**AGENDA**  
**PLANNING COMMISSION REGULAR MEETING**  
**CITY OF FARMINGTON HILLS**  
**JANUARY 20, 2022 7:30 P.M.**  
**FARMINGTON HILLS CITY HALL – CITY COUNCIL CHAMBERS**  
**31555 W. ELEVEN MILE ROAD, FARMINGTON HILLS MI 48336**  
**Cable TV: Spectrum – Channel 203; AT&T – Channel 99**  
**YouTube Channel: <https://www.youtube.com/user/FHChannel8>**  
**[www.fhgov.com](http://www.fhgov.com)**  
**(248) 871-2540**

# Site Plan Review

Case: SP 67-12-2021  
Site: 31140 West 10 Mile; 0.21 acres  
Applicant: Nikolin Nokaj  
Plan Date: 12/13/2021  
Zoning: B-3, General Business District

**SUBJECT:** Revised Building Supply Shop  
PJ #: 23-21-52 SP#: 67-12-2021 (Previously SP#: 58-3-2021)  
31140 W. 10 Mile Road  
22-23-23-351-036

SHEET TITLE  
**PROPOSED SITE PLAN**

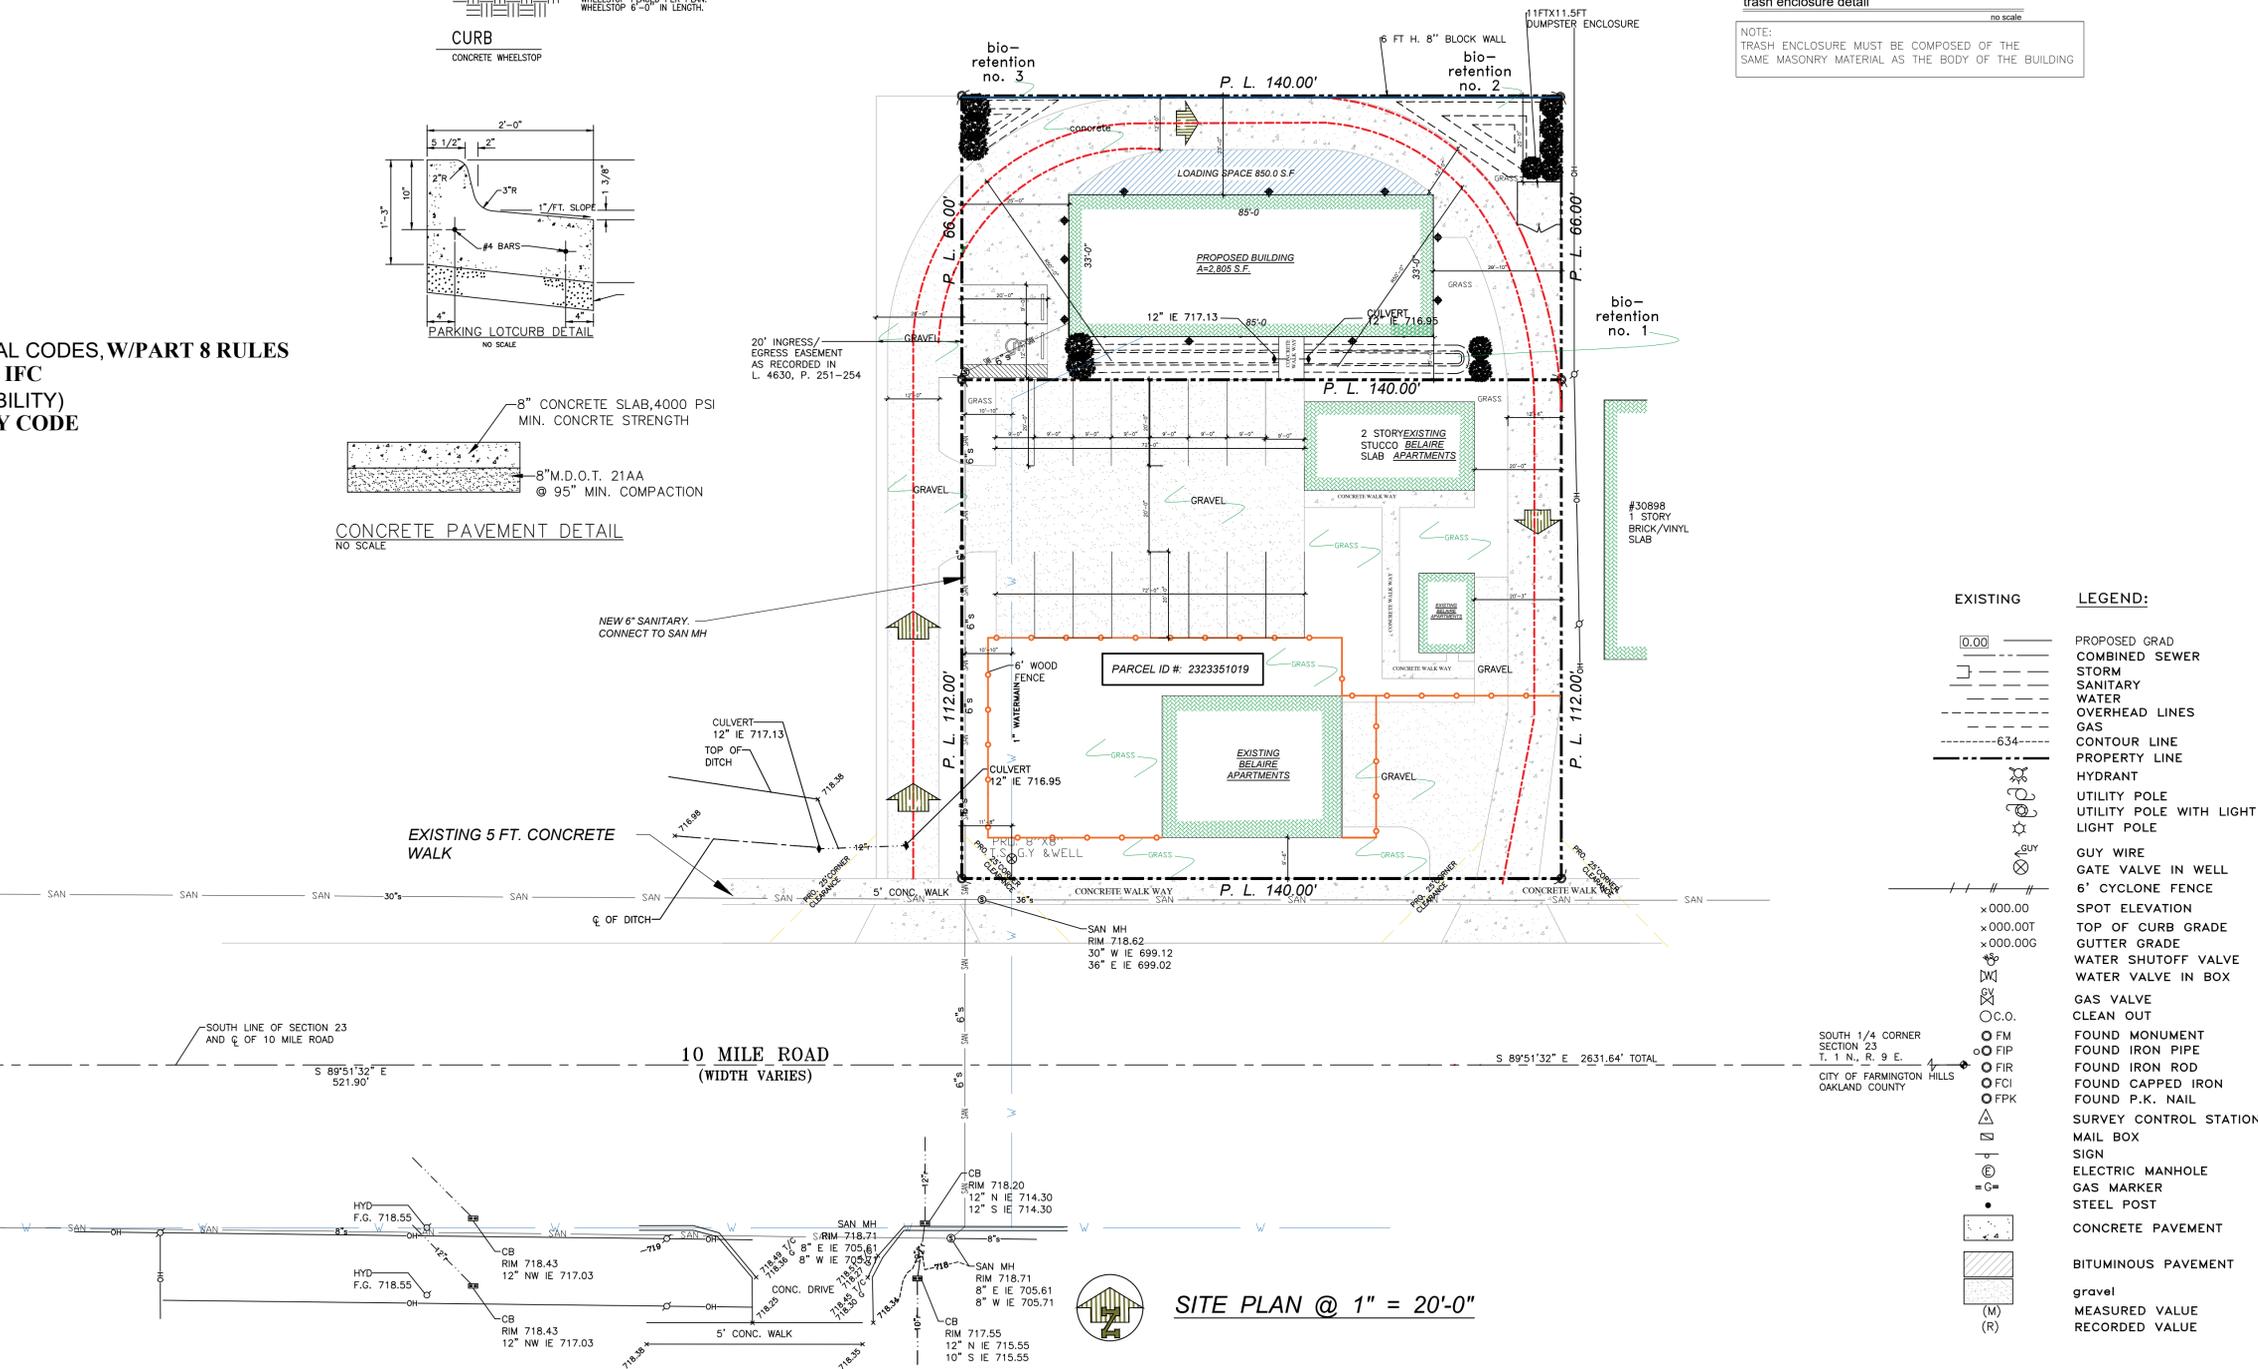
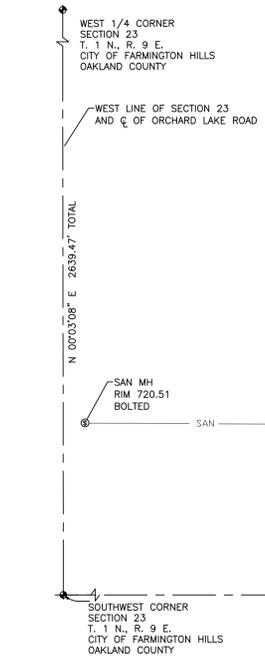
2. **Existing site.** The site is approximately 0.21 acres, but per the plan, the applicant is proposing to use some of the property to the south as well. This property is under common ownership. The site where the new building is proposed is undeveloped at present, but there appears to be a portion of

unimproved driveway on it. The site to the south where the parking lot and driveway will encroach is occupied by multiple dwelling units in three buildings, which are a nonconforming use (**these are not shown in full on the survey**). The plans do not indicate any proposed changes to the dwellings, we do note that the driveway exits across what is now a driveway/parking area for the units. **The plans do not indicate how many units there are or how many vehicles can be parked on this site with the new driveway. This configuration should not be approved if it will create noncompliance with the residential parking requirements. Signage must also be posted to keep traffic from going the wrong way on the one-way drive. The plans also do not note any plans for the fence that currently crosses the area where the driveway is proposed.**

8. **Barrier Free Parking.** For 18 spaces, a minimum of one accessible space is required; one is marked on the plan.
9. **Other Parking Lot Design and Layout Standards.** Per Section 34-5.3.11, parking lots and maneuvering lanes shall be surfaced with asphalt or concrete. **The large parking lot is proposed to be gravel, as is the driveway in the access easement.** The parking lot is also a dead-end, and while it is only 8 spaces deep and therefore not in violation of Section 34-5.3.15, **the last two spaces at the eastern end of the lot may pose maneuvering problems, as they are flush with the edge of the lot. As they are excess spaces, we recommend that they be removed. The parking lot should also have bumper blocks to keep vehicles from hitting the fence to the south and the landscaping to the north.**

11. **Corner Clearance (34-5.10).** Corner clearance standards are met.
12. **Landscape Development (34-5.14).** **The plan indicates three-foot shrubs and five maple trees along the southern property line near the closest residential building. The plan shows 17 total maple trees (the landscaping schedule says 18), and 4 evergreens west of the of the parking lot; the plans indicate that these are intended to screen the lot, but the two south of the driveway could create visibility issues with northbound traffic on the driveway; the northernmost of these should be replaced with a deciduous tree and a low hedge (max 30 inches). In general, the trees shown on the plan are spaced very close together, in a manner that may not be conducive to their long-term health.**

**LANDSCAPE PLAN**

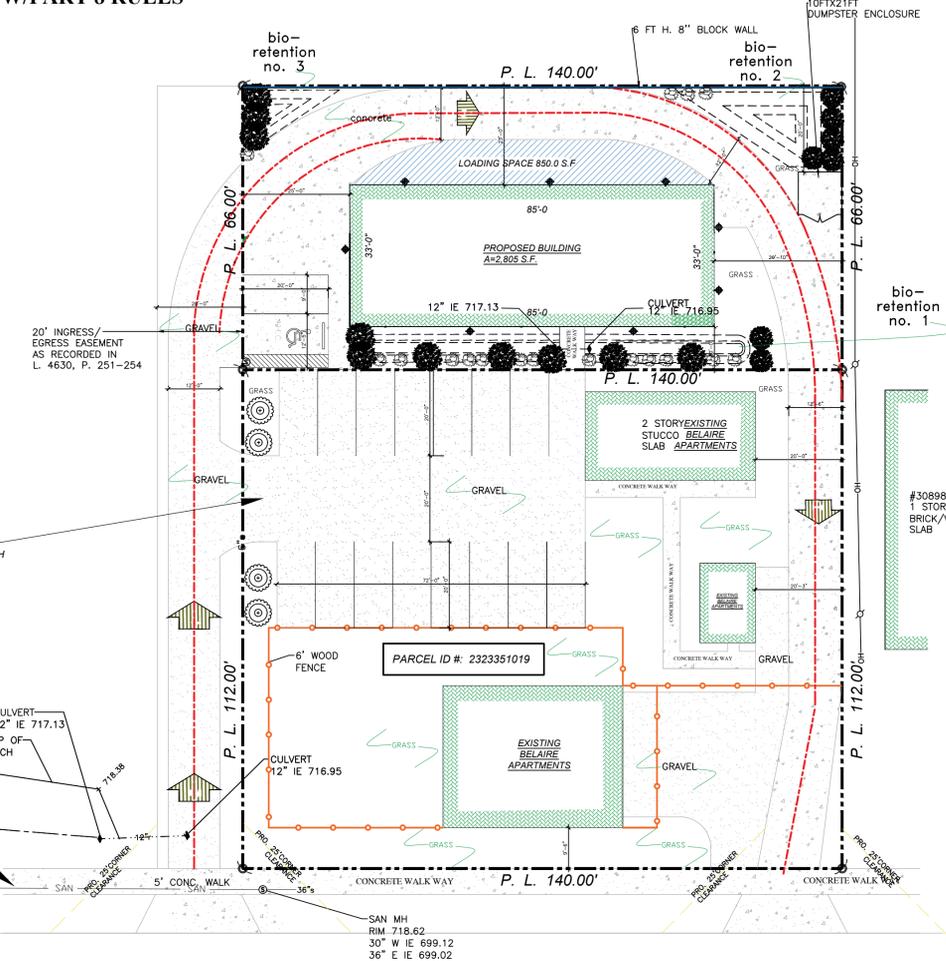
5. **Screening Wall (34-5.15).** The required 6-foot wall is indicated along the northern property line on Sheet LS-1, but **no details are provided**. Five deciduous trees are required on the non-residential side of the wall; **all trees are located in the corners, rather than along the wall**. The plans note that a variance will be requested for these trees.

13. **Tree Removal & Replacement.** The site appears to have several trees, but no tree inventory or survey is provided; it appears that all would be removed to accommodate this plan.

**SHEET TITLE**  
**LIGHTING AND PHOTOMETRIC PLAN**

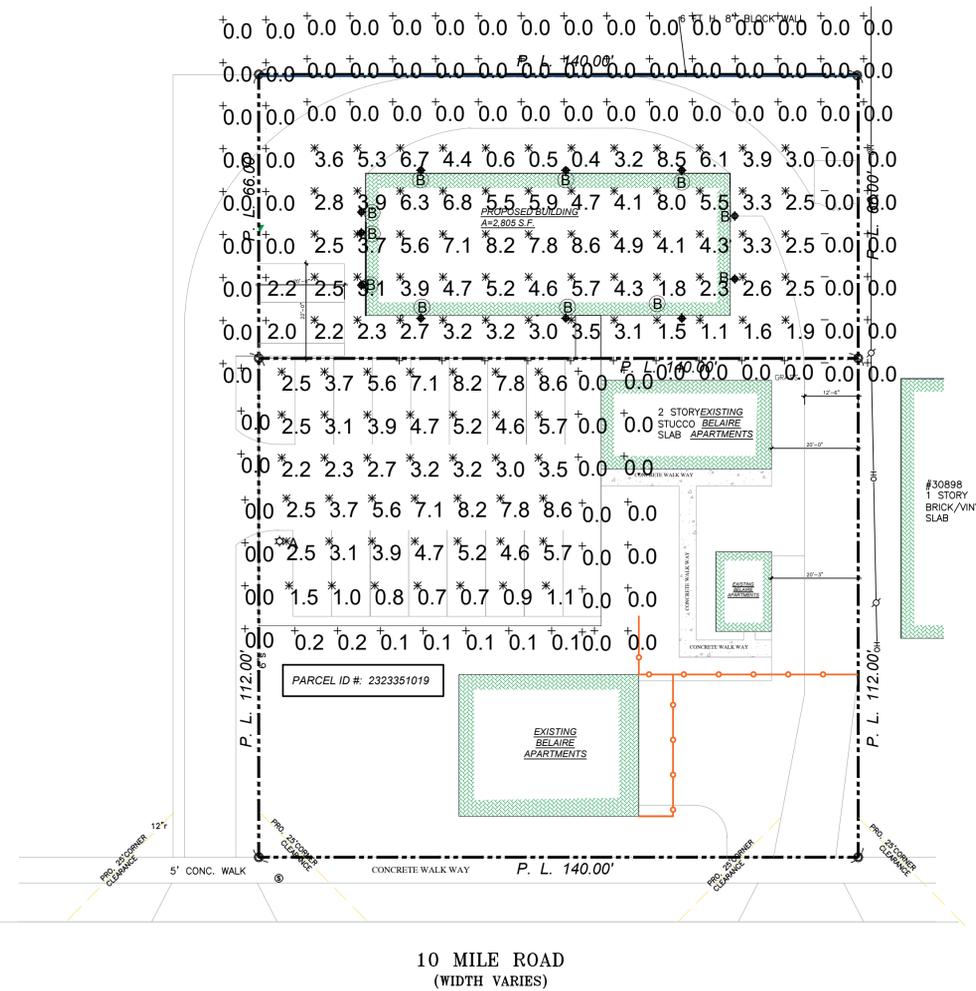
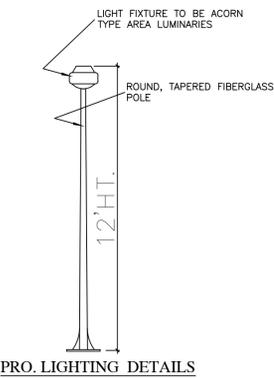
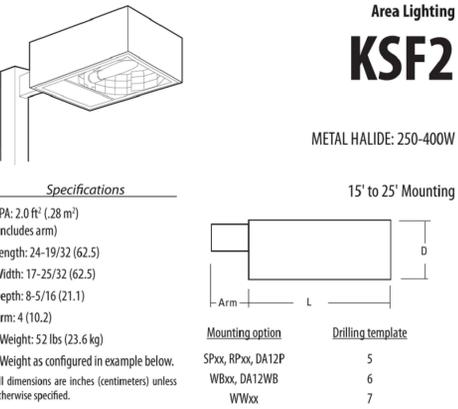
a. **Illumination Levels.** The lighting plan indicates eleven wall packs and one pole-mounted fixture in the parking lot, all meeting the cut-off requirements of the ordinance.

- b. Maximum illumination at the property line shall not exceed one-third (1/3) foot-candle. **This standard may be met. But the photometric plan does not show enough points to tell along the western property line.**

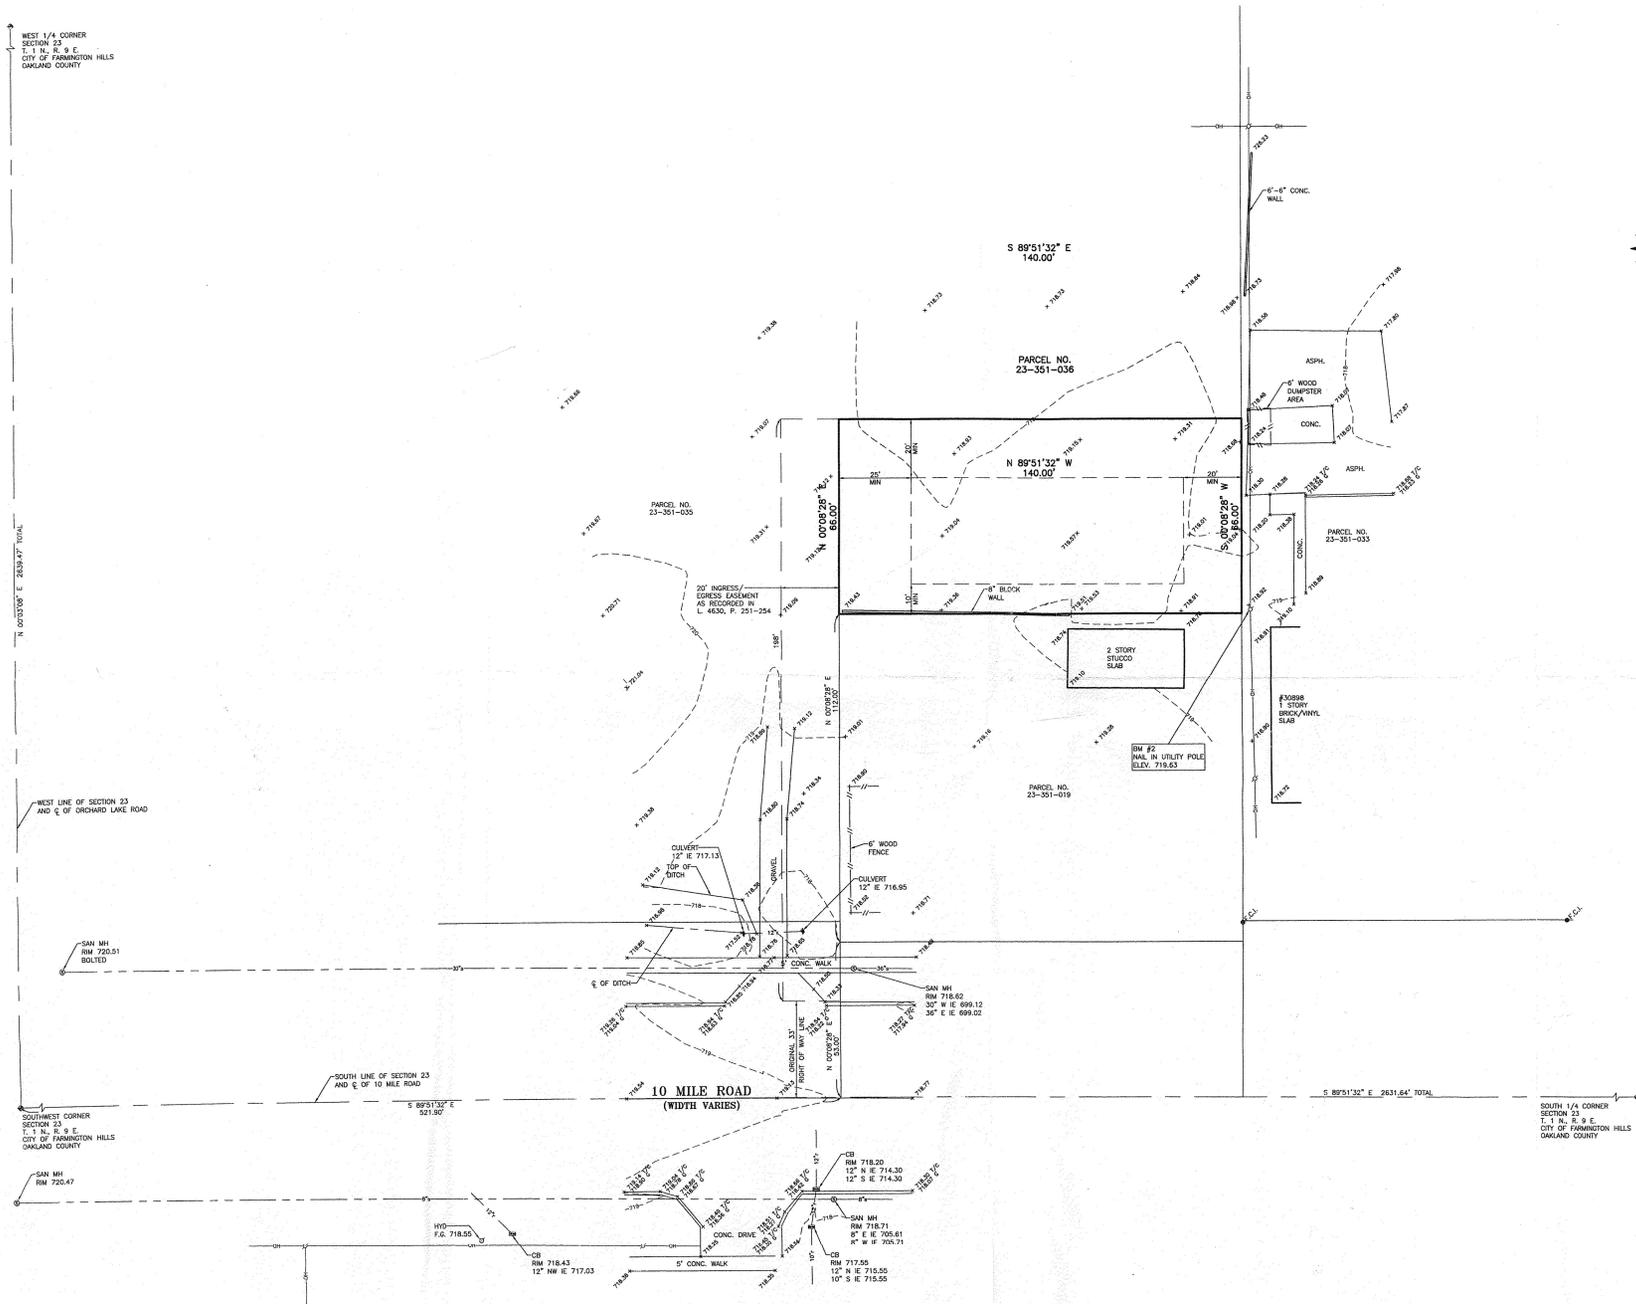
17. **Survey.** The survey does not show the full extent of existing development on the multi-family site, making a comparison between proposed and existing conditions difficult.
